# Cable, Gear Selector, Replacement

M-432-002A

Mack MMD model vehicles equipped with 2500 series Allison transmissions.

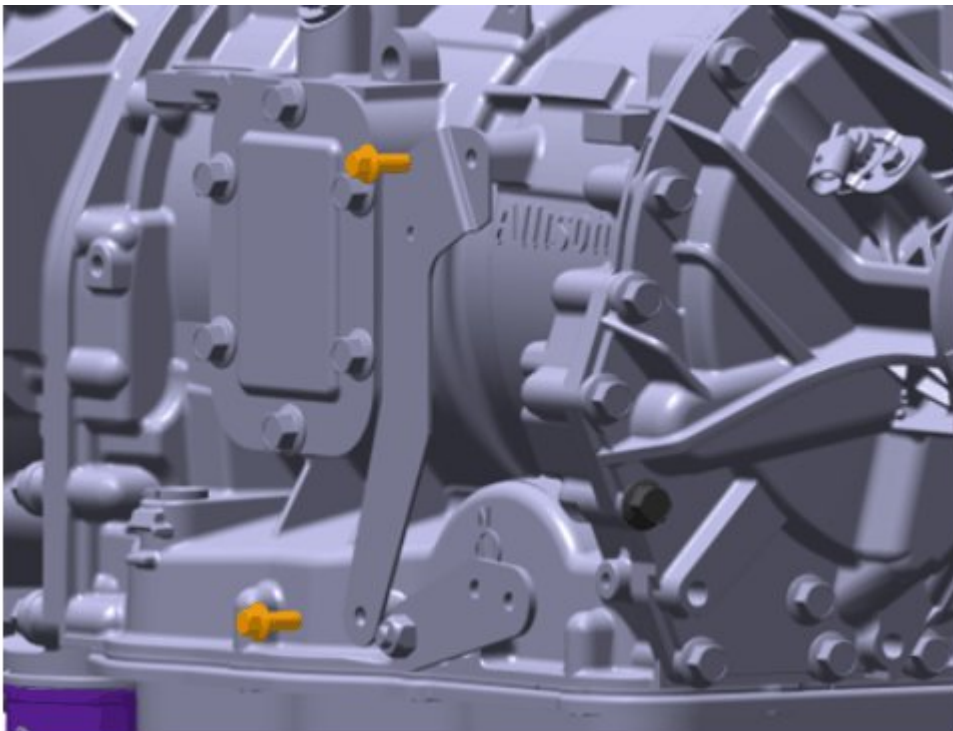
Mack Trucks has identified that MMD model vehicles equipped with a 2500 series transmission may produce a buzzing or chirping noise in the cab. This is due to the transmission shift cable transmitting vibrations from the powertrain components. A new shift cable and mounting bracket have been developed to resolve the issue. Follow the instructions below to install the updated parts.

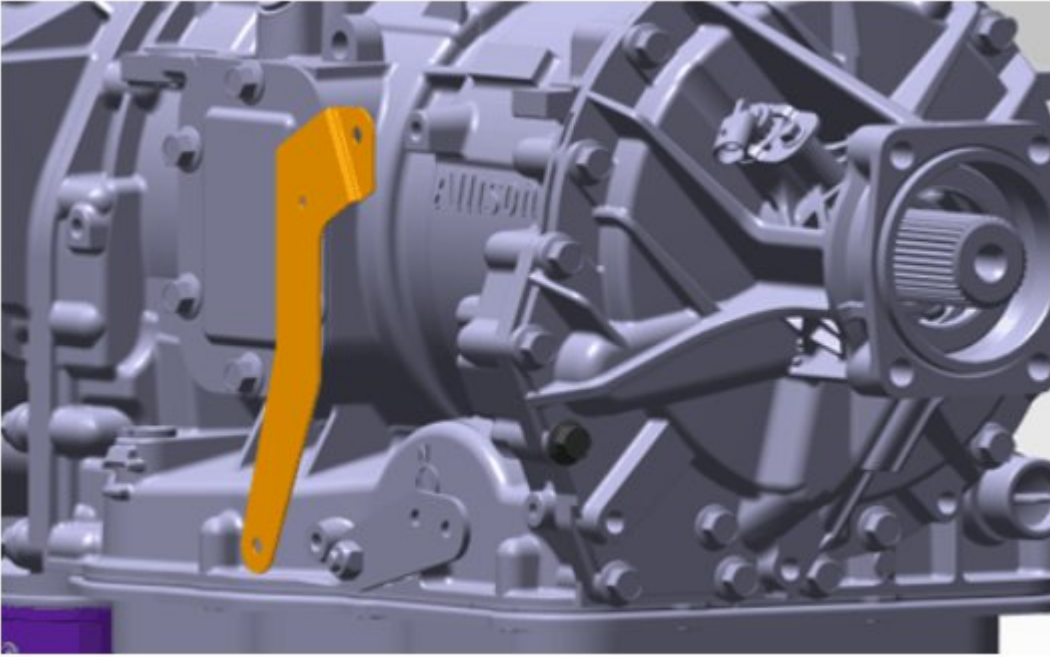
4. Remove the bracket.

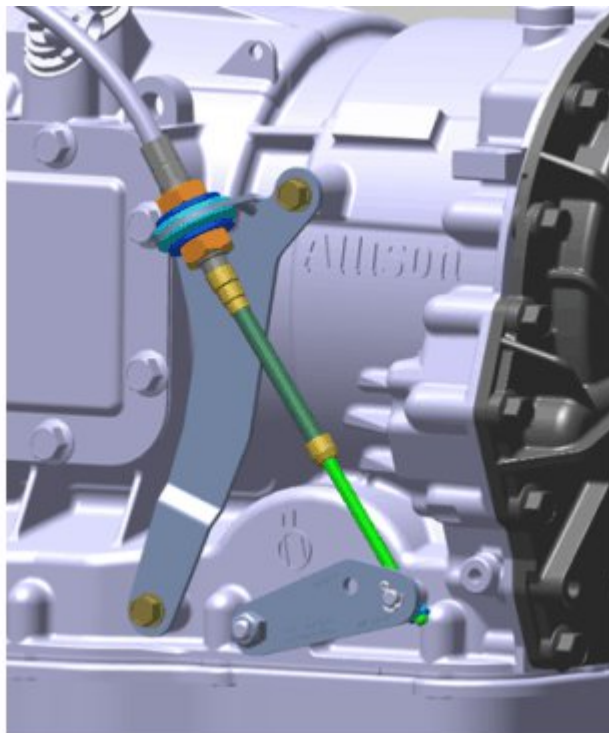
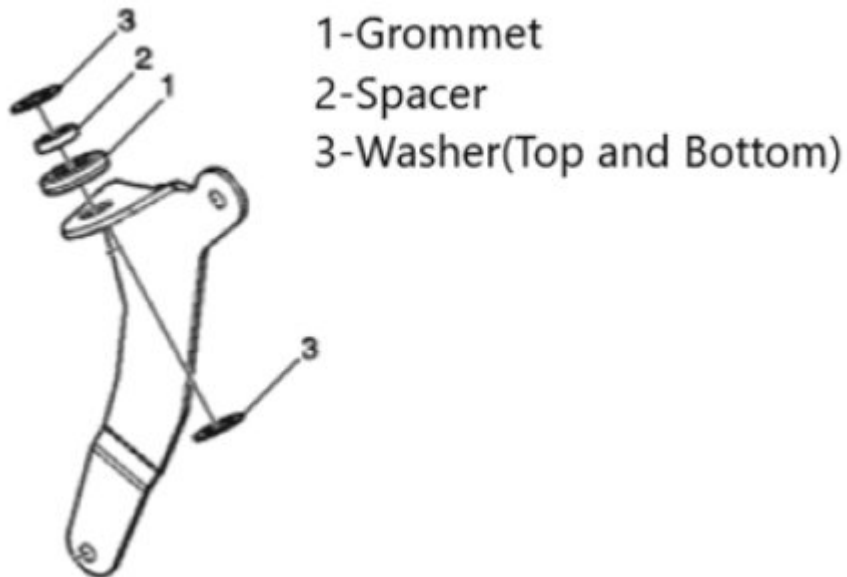
5. Install the new shift cable bracket and assemble the new shift cable.

| Shift Cable Bracket, screws | 24 ±4 Nm (18 ±3 lbf-ft) |

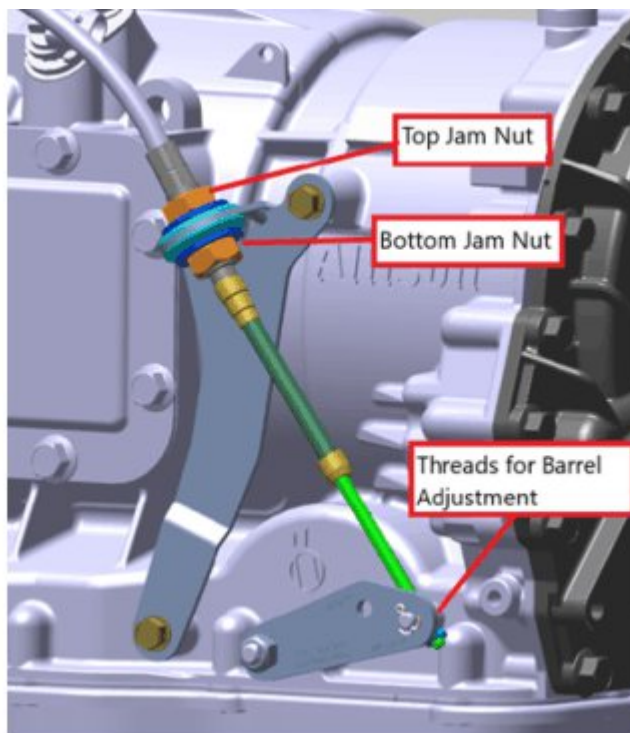
6. Install the bottom jam nut first. Set the position to provide adequate barrel threads (at the end of the cable) for adjustment.

7. Once set, tighten the top jam nut against the spacer.
